**ISSUE:** Permit to Demolish/Capsulate (partial) and Certificate of Appropriateness for alterations and addition.

**LOCATION:** Old and Historic Alexandria District  
414 Franklin Street

**STAFF RECOMMENDATION**

Staff recommends approval of the Permit to Demolish/Capsulate and the Certificate of Appropriateness for alterations and addition with the condition that:

**Figure 1- Proposed front/north elevation**

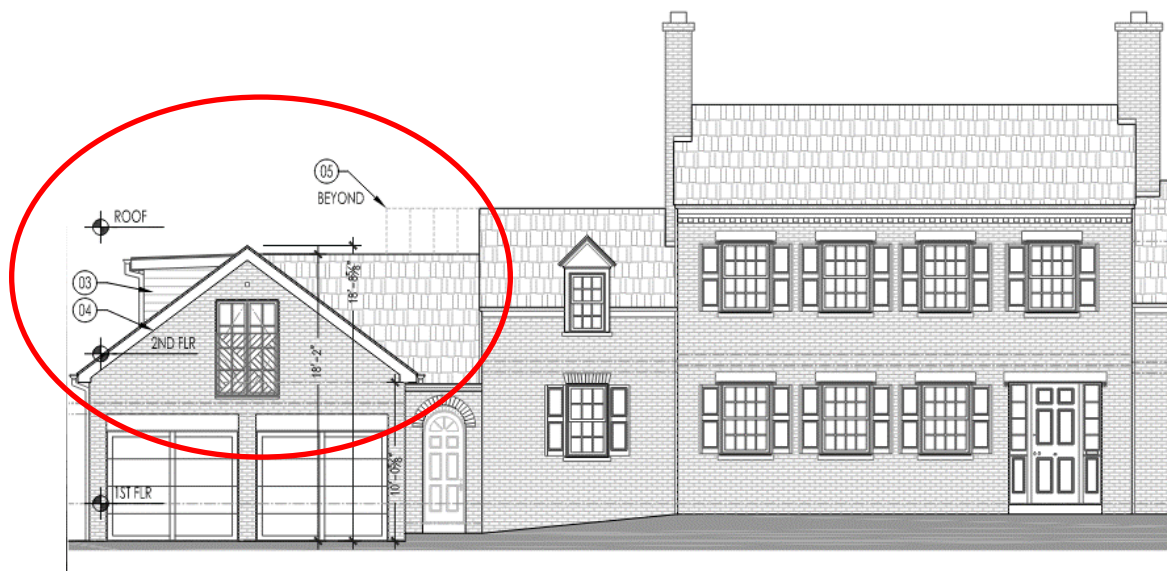
The project calls to raise the existing garage slate roof to be reused to the extent possible. The masonry gable will remain and be patched as required; the rear addition back wall and the side of the proposed shed dormer on the east elevation/garage roof will be partially visible as shown on Figure 1 below.

The side of the proposed northernmost dormer will be visible from the Franklin Street main elevation; however, staff does not believe that the projection of the dormer's side on the garage roof will impact the overall property visual integrity.

PROPOSED EAST ELEVATION

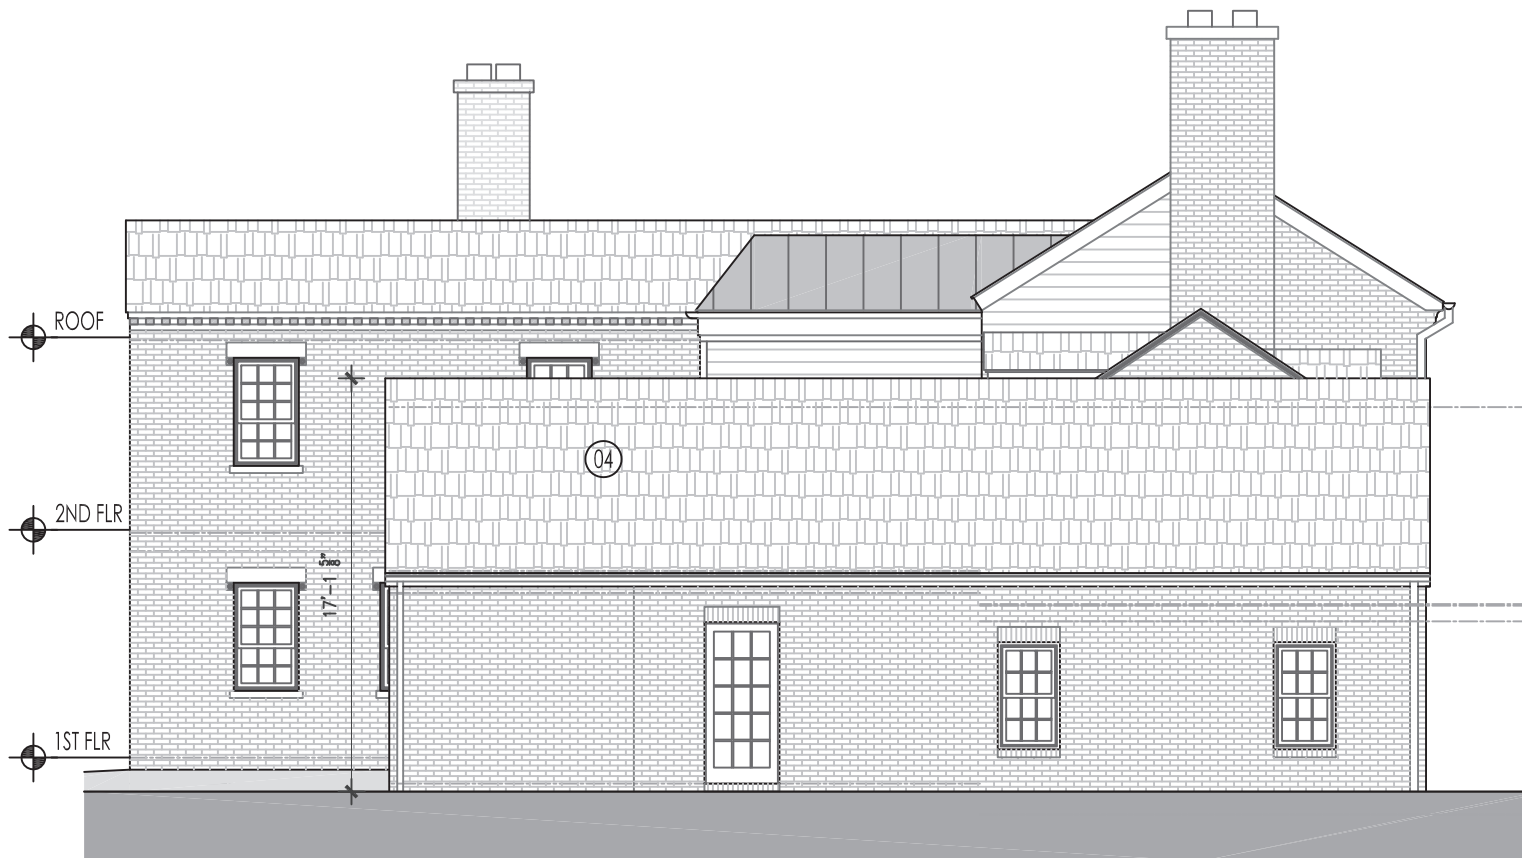
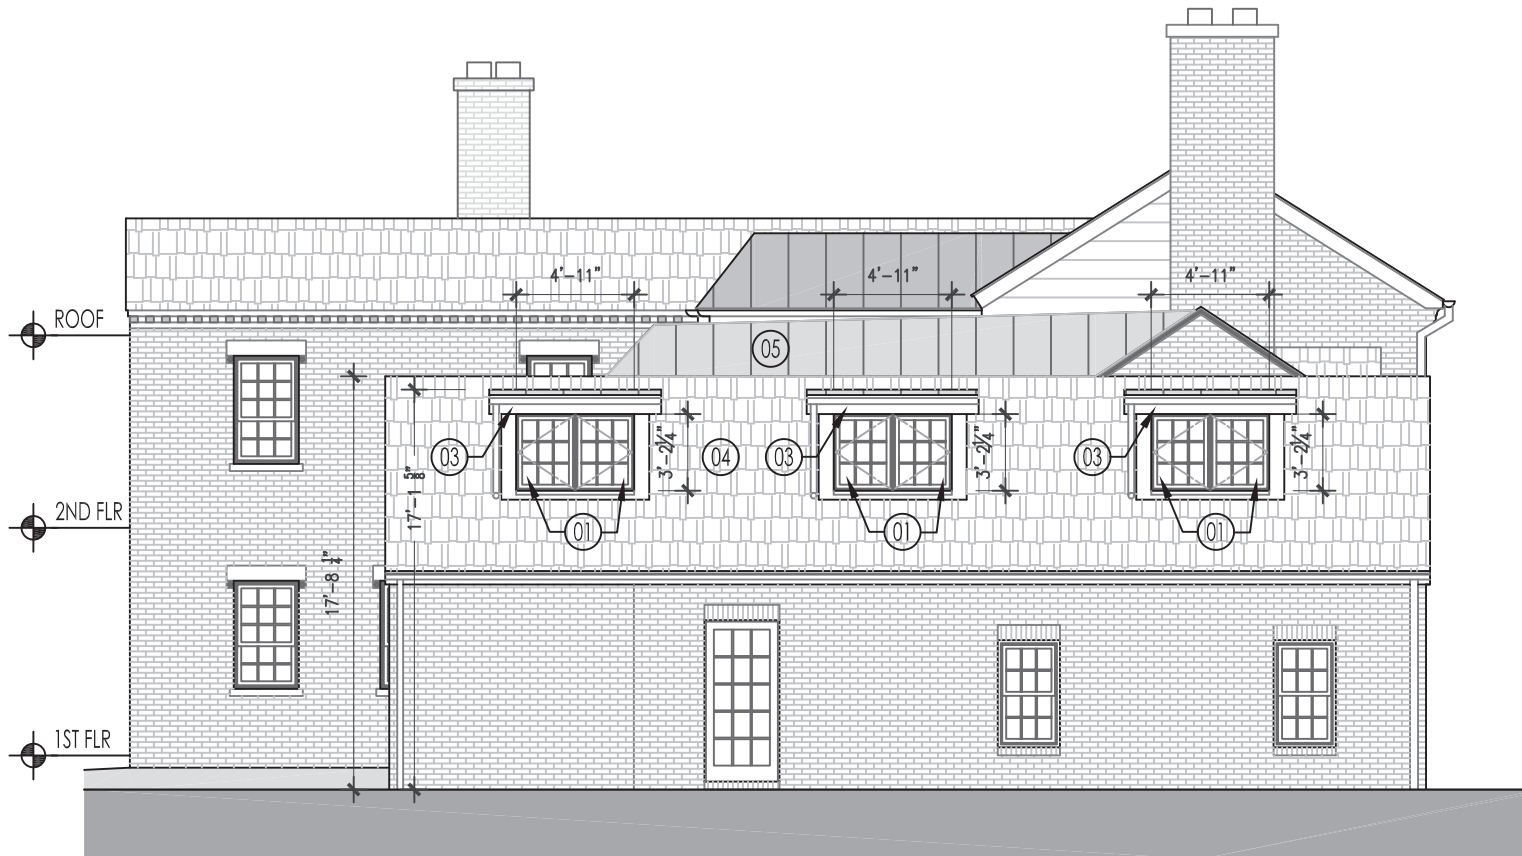
The project calls for the installation of three shed dormers with multilight casement, aluminum-clad windows, each on the raised garage roof. The proposed dormers will be clad with smooth finish fiber cement siding and will have standing seam copper roof (Figure 2)

The *Design Guidelines* state that "Dormers provide light and ventilation to the top floor of a building and can increase the usable floor area. At the same time, dormers are particularly visible elements of a roof and can have adverse impacts on a building if not properly designed and sited. As a general rule, dormers should not be too large for the structure." Furthermore, "The style of the dormer should be appropriate to the architectural style of the existing structure." And "Shed dormers are strongly discouraged."

Although shed dormers are strongly discouraged, the proposed dormers will mostly be visible on the secondary west elevation, on the garage addition's roof which has not acquired historic significance on its own merit and does not have a distinguished architectural design.

Therefore, with the condition that the applicant submit updated window specifications with the building permit to confirm that the proposed windows meet the Alexandria New and Replacement Window Performance Specifications in the Historic District, staff recommends approval of the project.
